Access Compliance Report

Public Rights-of-Way

(Curb Ramps)

Intersection ID: 15377	Main Street: ELMHURST_RD	Cross Street: HAVERFORD_PL	Location:	N
ADA ID: D512917E53A0	Ramp Type: Directional1	Initial Pass/Fail: Fail	Overall Compliance: No	Severity Score: 25

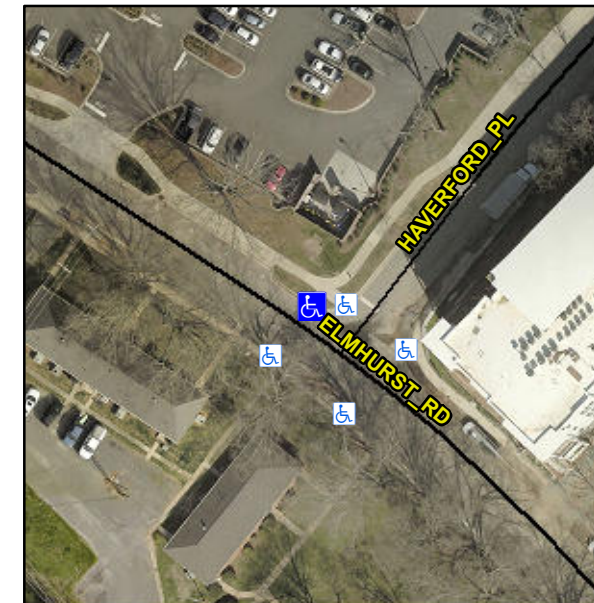
R304.2.2

Compliance	Description	Data	Compliance	Description	Data
N/A	Ramp Length (in)	78.0	N/A	Grade Break?	N/A
Yes	Ramp Width (in)	71.0	N/A	Grade Break Slope (%)	0.0
No	Ramp Slope (%)	12.1	N/A	Grade Break XSlope (%)	0.0
Yes	Ramp XSlope (%)	1.8			
N/A	Flare Type LT	N/A	N/A	Flare Type RT	N/A
N/A	Flare Slope LT (%)	N/A	N/A	Flare Slope RT (%)	0.0
N/A	Flare Traversable LT?	N/A	N/A	Flare Traversable RT?	N/A
N/A	Landing Length (in)	0.0	N/A	DWS Provided?	N/A
N/A	Landing Width (in)	0.0	N/A	DWS Contrast?	N/A
N/A	Landing Slope (%)	0.0	N/A	DWS Length (in)	N/A
N/A	Landing X Slope (%)	0.0	N/A	DWS Full Width?	N/A
N/A	Landing Curb? (Y/N)	N/A	N/A	DWS Offset LT (in)	N/A
N/A	Shared Landing?	N/A	N/A	DWS Offset RT (in)	N/A
N/A	Gutter Ponding?	0.0	N/A	Gutter Slope (%)	N/A
N/A	Gutter Lip Ht (in)	0.0	N/A	Gutter X Slope (%)	N/A
N/A	Painted X Walk1?	No		Road Slope (%)	1.1
	X Walk 1 Direction	To SW		Road X Slope (%)	1.3
	X Walk 1 Width (in)	N/A		Clear Space?	N/A

Remove & Replace Entire Ramp.
